SK-RFI3460R00-E265

DETAILS
TOWER AND SUSPENSION CABLE
TOWER POWER AND LIGHTING

SK-RFI3460R00-E337
R. GARCIA AUGUST 20, 2013

DETAILS
SCADA REMOTE TERMINAL UNIT SYSTEM
~~#TEL-4~~ TERMINAL CONNECTION DIAGRAM

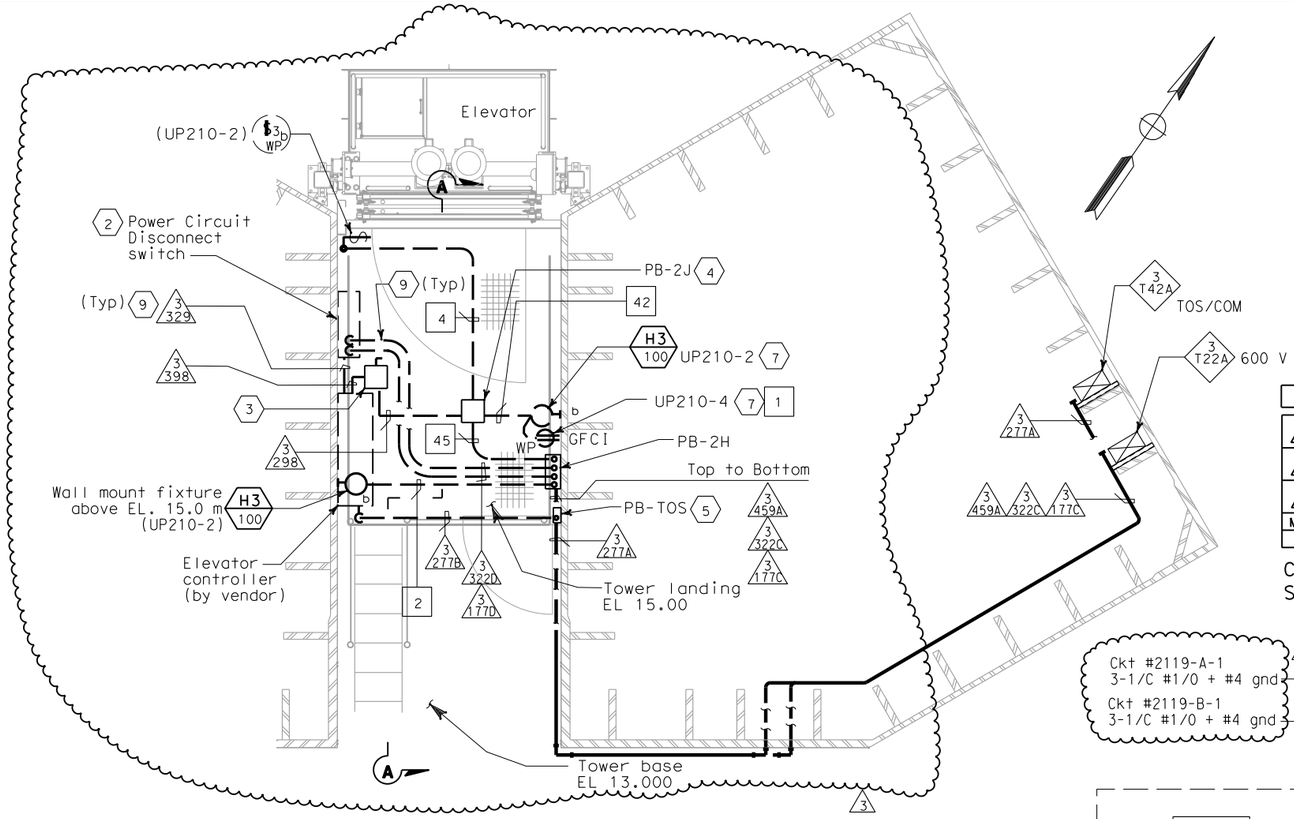
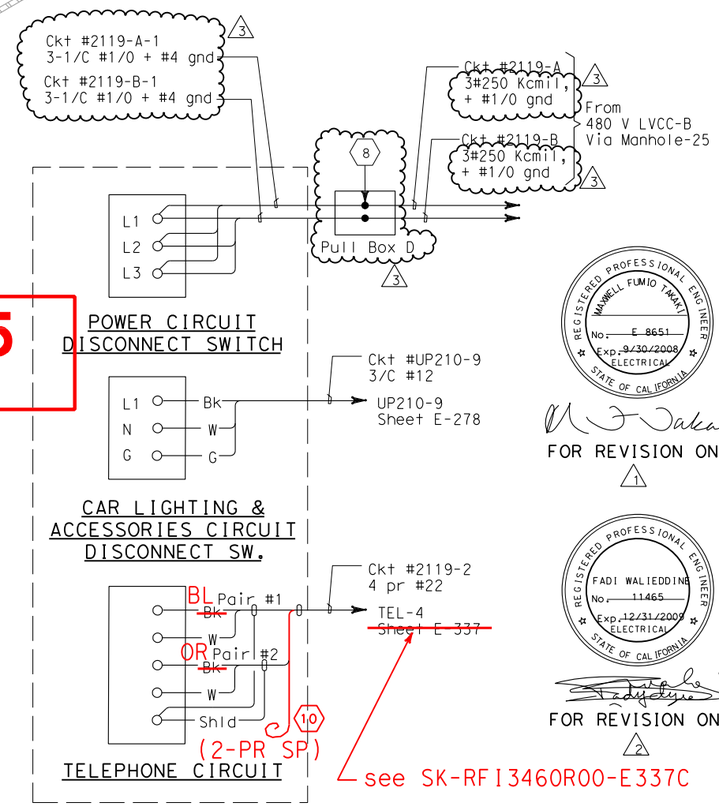
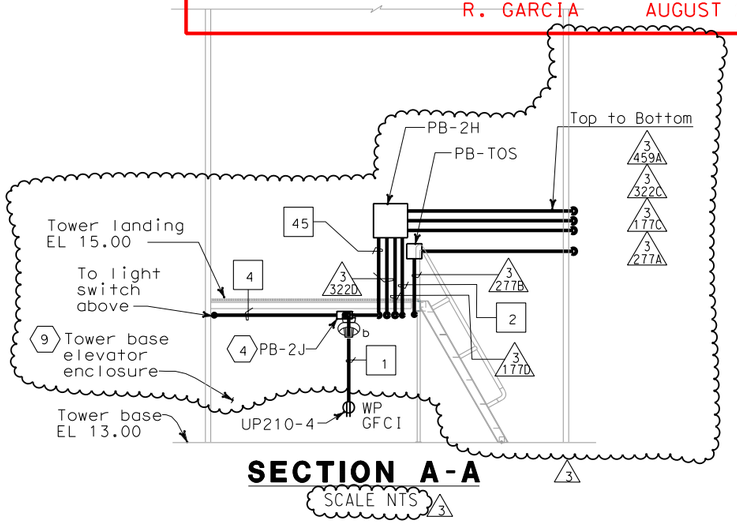
1. Deleted.
2. 480 V, 3 Ø, 100 A, non-fused disconnect switch for elevator pit motor. Use liquid tight flexible conduit from disconnect switch to the motor.
3. 120 V single pole single throw disconnect switch for elevator lighting and fan. Mounted DS between power circuit disconnect switch and controller.
4. Mounte below Elevation 15.0 m grating. 3
5. PB-TOS for telephone communication lines.
6. 3
7. For additional lighting and receptacles at EL. 9.00 M, see sheet E-266.
8. Splice conductors inside pull box "PB-D" see drawing E-264A
9. Conduit routing inside elevator enclosure may be adjusted to suit field condition.
10. Spare cable or conductor ends shall be coiled and taped. 3

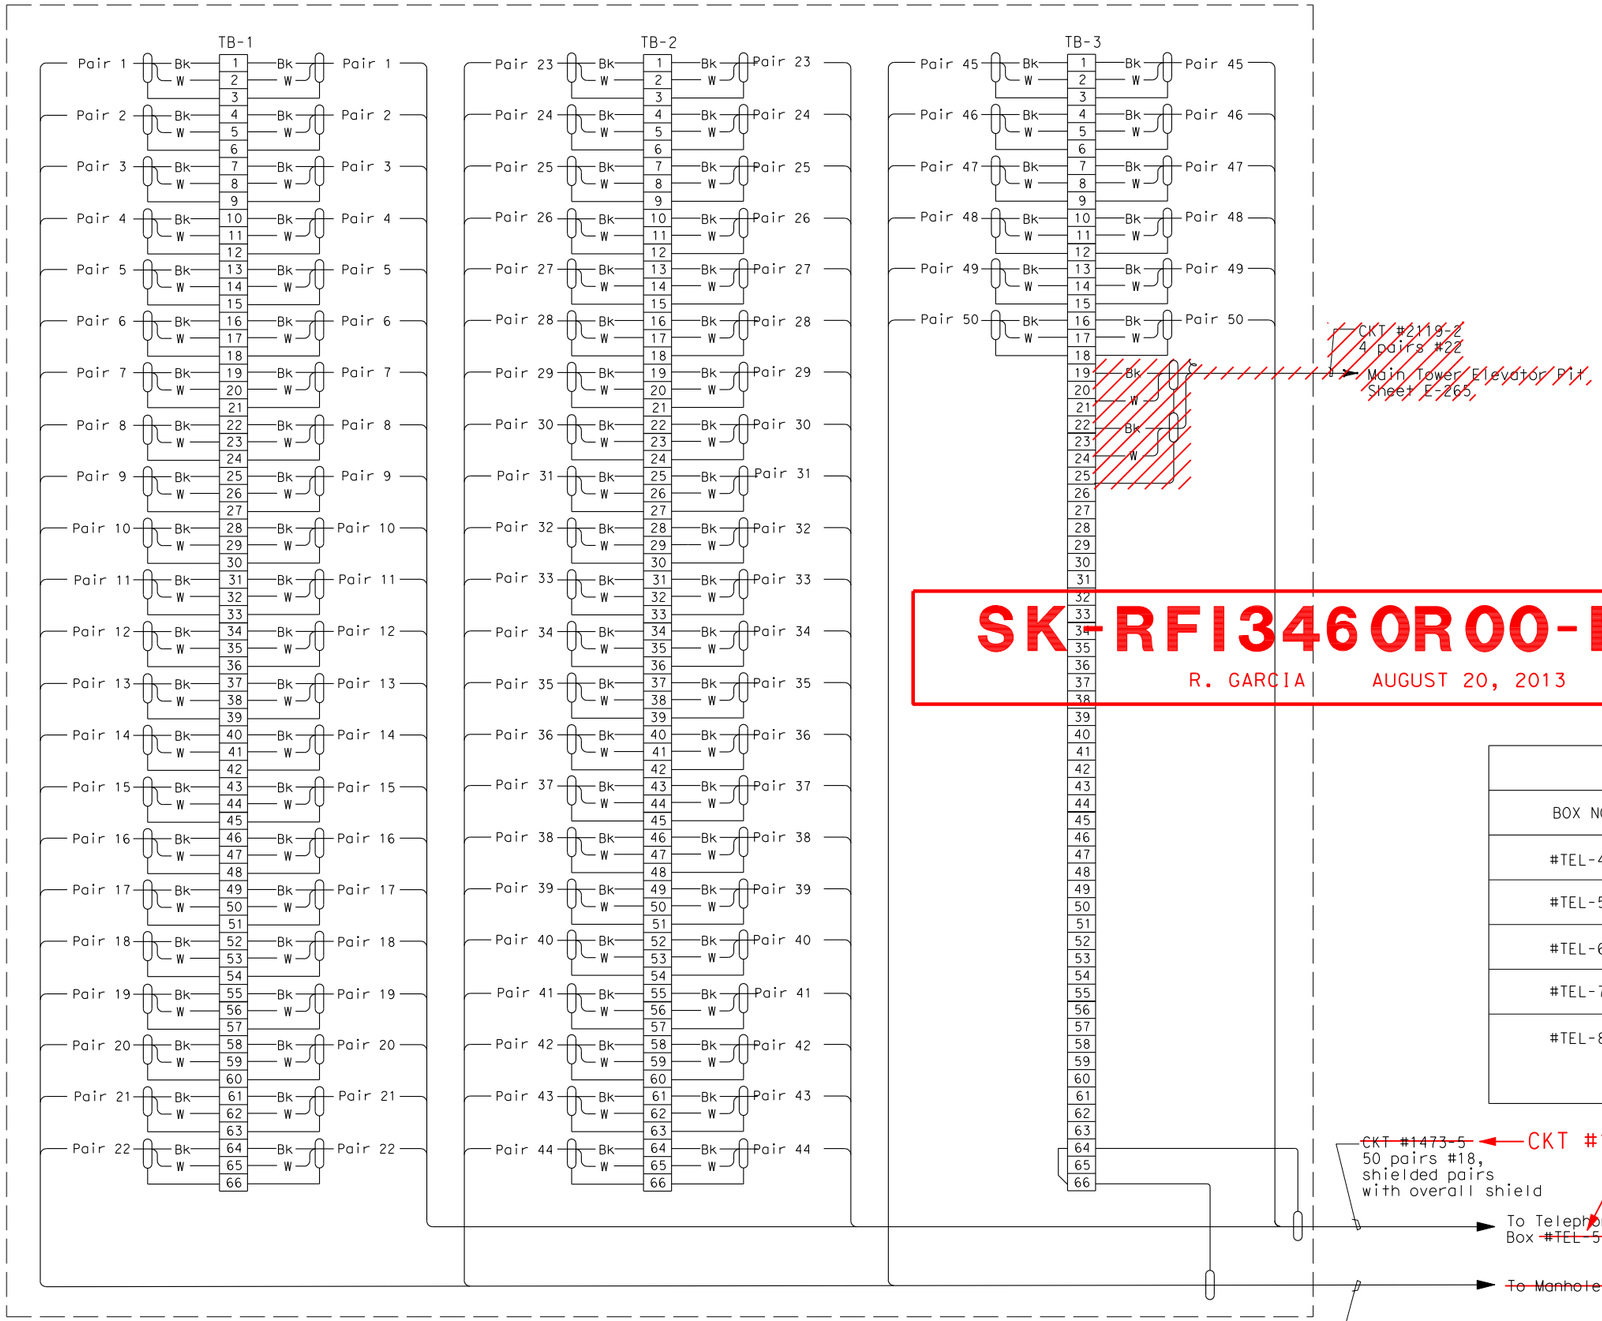
1. For cable/circuit number, see Table A.
2. Use Table A in conjunction with cable block diagram sheet E-317.
3. ~~The Contractor shall extend and coil 5 meters of cable in Manhole-27. All cables shall be tagged with circuit numbers as shown. For location of Manhole-27, see sheet E-11.~~

BOX NO.	CABLES		REMARKS
#TEL-4	~~1473-4~~	~~1473-5~~	For cable interface, see SK-RFI3460R00-E337C
#TEL-5	~~1473-5~~	~~1473-6~~	For cable interface, see SK-RFI3447R00-E337D of RFI 3447R00 response
#TEL-6	1473-6	1473-7	
#TEL-7	1473-7	1473-8	
#TEL-8	1473-8	—	
	1473-10	2473-10	For cable interface, see sheet E-316, sheet notes 1 and 2

Shown for ~~#TEL-4~~, See Table A for other terminal boxes

DETAILS
SCADA REMOTE TERMINAL UNIT SYSTEM
#TEL-4 TERMINAL CONNECTION DIAGRAM

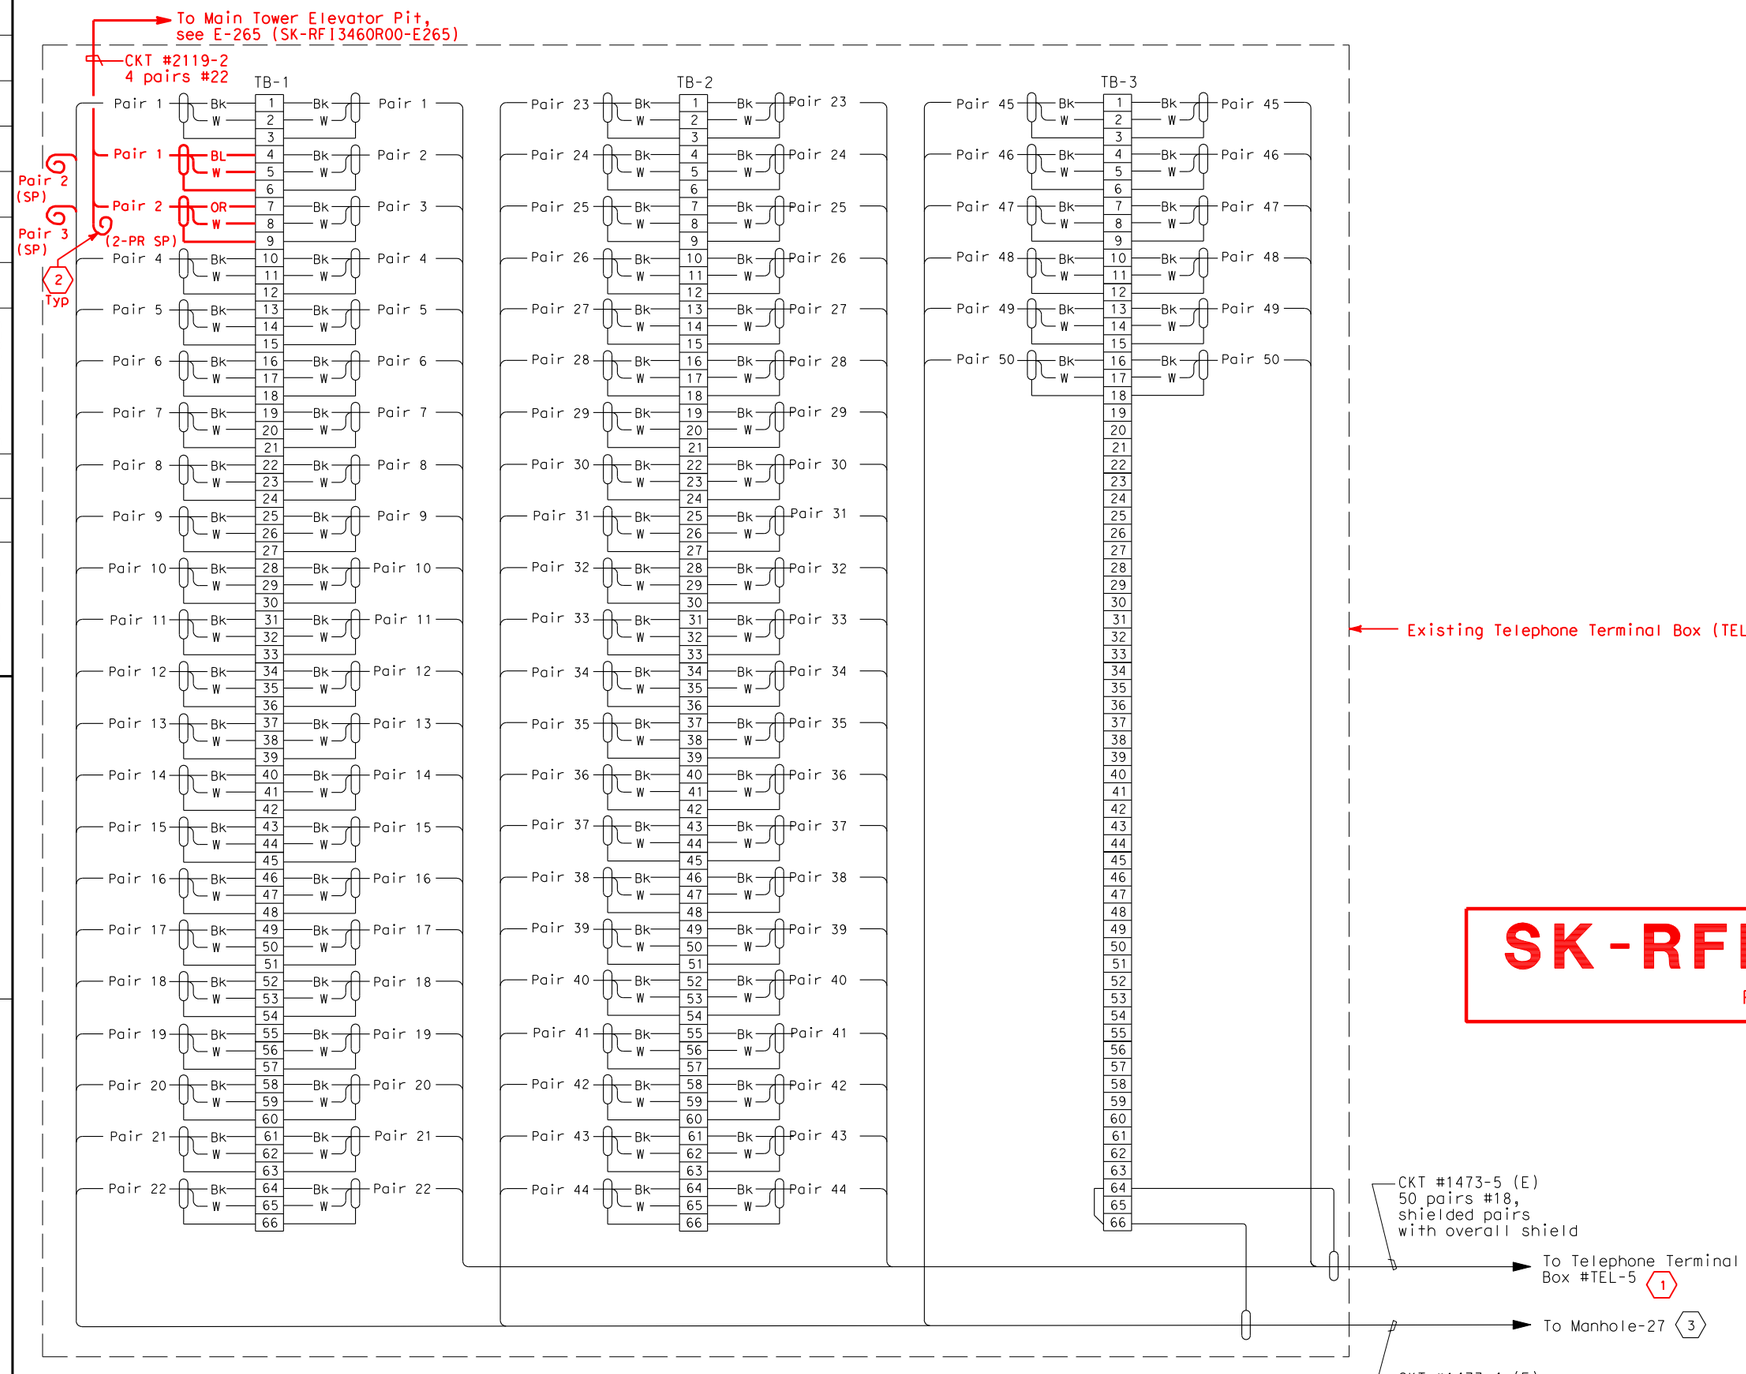
1. For terminal connection diagram and continuation to TEL #5, see SK-RFI3447R00-E337D of RFI-3447R00 response.
2. Spare cable or conductors ends shall be coiled and taped.
3. The Contractor shall extend and coil 5 meters of cable in Manhole-27. All cables shall be tagged with circuit numbers as shown. For location of Manhole-27, see sheet E-11.
